Order Instituting Rulemaking to Modernize
the Electric Grid for a High Distributed
Energy Resources Future.

Rulemaking 21-06-017

**COMMENTS OF THE PUBLIC ADVOCATES OFFICE
ON THE ELECTRIFICATION IMPACT STUDY PART 2
DRAFT REPORTS**

Figure 1: Example of Hexagonal Allocation

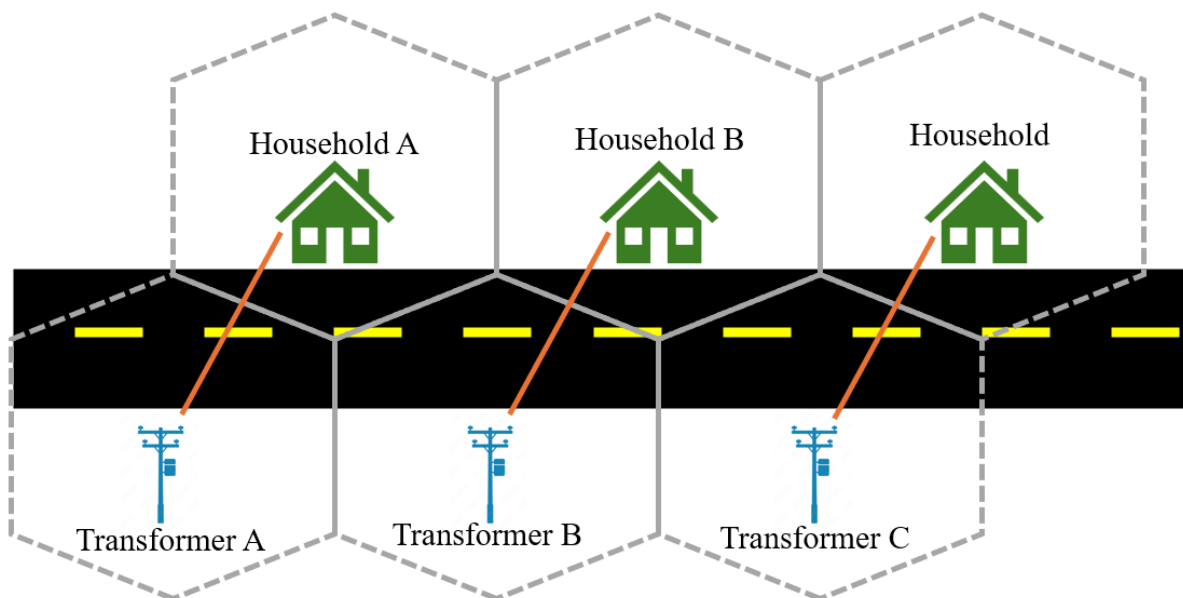
In this example, each service transformer has 25 kVA of available capacity, and each house has 20 kW of load growth. While Household A is served from Transformer A, it is close enough to Transformer B that it could also be served from Transformer B. However, Household A is not close enough to Transformer C to be served from Transformer C. The same principles apply to the other households.

The method Kevala used in EIS Part 1 would allocate new load directly to existing service transformers.³¹ Because each service transformer can accommodate the load growth on the house it is connected to, no new service transformers or other upgrades are necessary.

The method used in PG&E's Draft EIS Part 2 allocates new load spatially, and then associates load spatially with capacity on nearby service transformers.³² Starting with Household A, its load could be assigned to either Transformer A or Transformer B,

as both are in adjacent areas and PG&E's spatial method does not associate loads with specific service transformers. If load is assigned to Transformer B, Transformer B no longer has available capacity, so Household B's load must be assigned to Transformer C. Transformer C no longer has available capacity, so Household C appears to need a new service transformer, even though capacity is actually available for all three houses. Errors like this, if present, could compound to mistakenly allocate new service transformers for loads which can in fact be served from existing transformers.
